EUROPEAN MEDICINES AGENCY  
SCIENCE MEDICINES HEALTH

Amsterdam, 30 November 2020  
EMA/CHMP/641856/2020  
Committee for Medicinal Products for Human Use (CHMP)

## Quality rolling review CHMP overview and list of questions

COVID-19 mRNA Vaccine BioNTech

**Figure 3.2.S.2.2-1. RNA Manufacturing Process**

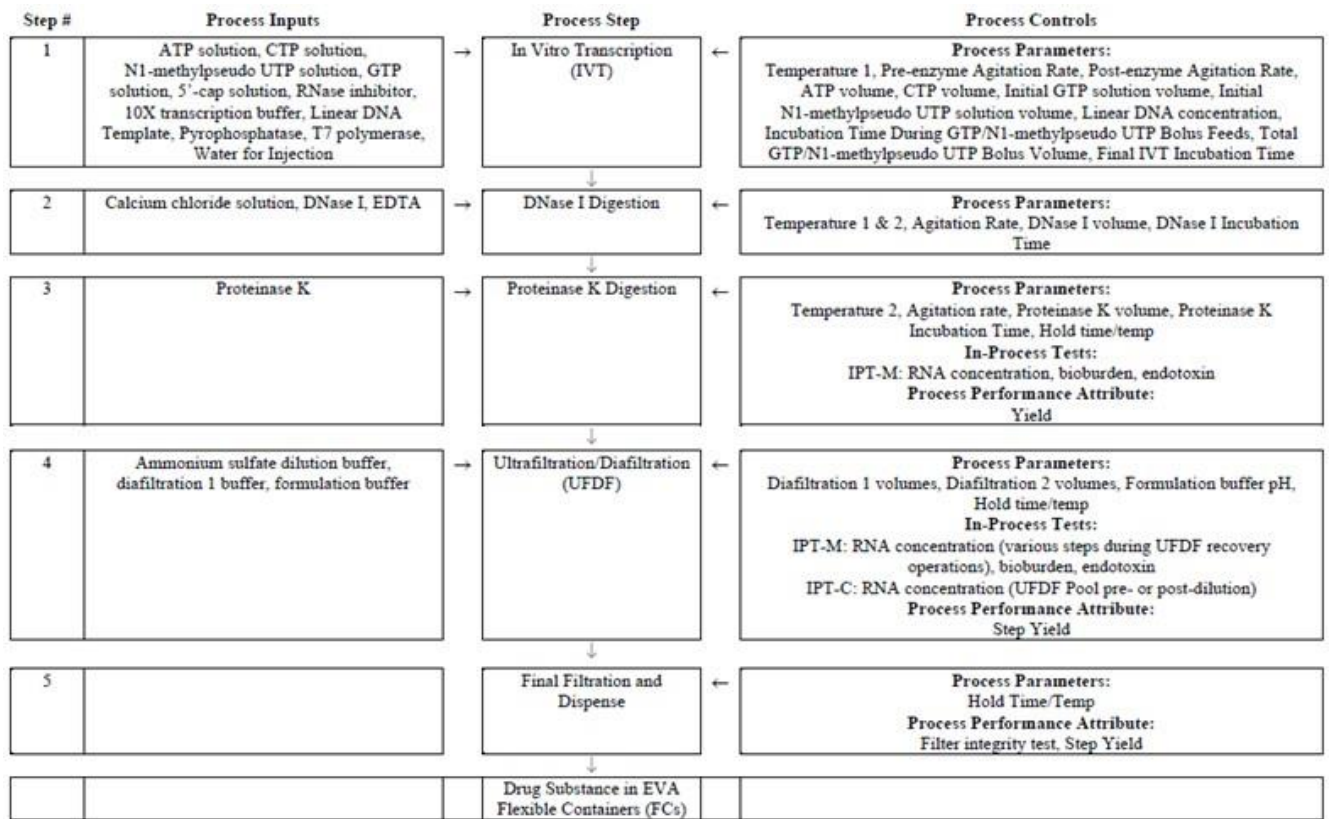
The Applicant explains that the UFDF membrane lifetime remain to be established and the concurrent validation plan is found adequately described in the dossier. The strategy could be found acceptable, provided that the Applicant will update the manufacturing process description with control of feed flow rates, transmembrane pressure and membrane surface area.
